RFP # 12-2023 – Security Camera System for Barkman Library Questions & Answers

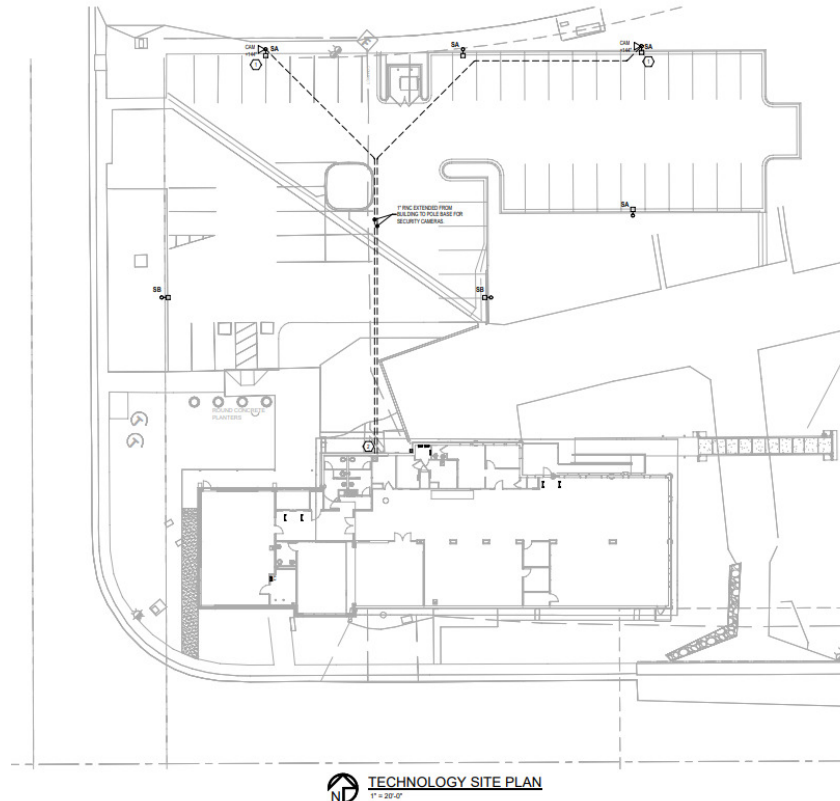
- Per the addendum, are you planning on running conduit to the poles for the cameras or would you like us to quote a wireless solution?
 - Conduit routing was chosen with an eye towards keeping the cameras within reach of a CAT6 cable to eliminate the expense of fiber or CAT6 extenders to the cameras. Below is the diagram of the run that will be made.

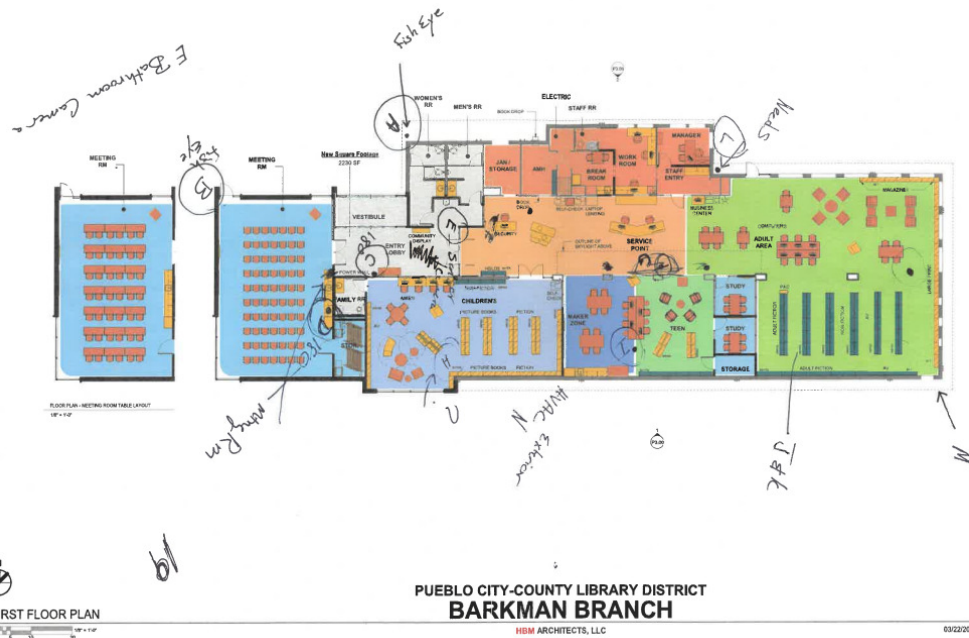
- What type of camera is required for the poles in the parking lot?
 - PoE++ CD62-E
- There was a pre-design of locations where PCCLD staff had suggested camera placement, is this available?
 - Yes it is below, note that camera E was a location that already had a Verkada camera that was removed. This was conducted by Flair Data before the remodel began and will be re-added to the front of the bathrooms by Flair Data to include the Verkada bathroom sensors that were removed. A drop must be included in the proposal for the camera and a drop per bathroom for the Verkada sensors, however quoting of the camera and sensors is not necessary. Please also note that the below is not a mandatory location of cameras but was an idea PCCLD prefers that location be suggested by the vendor.
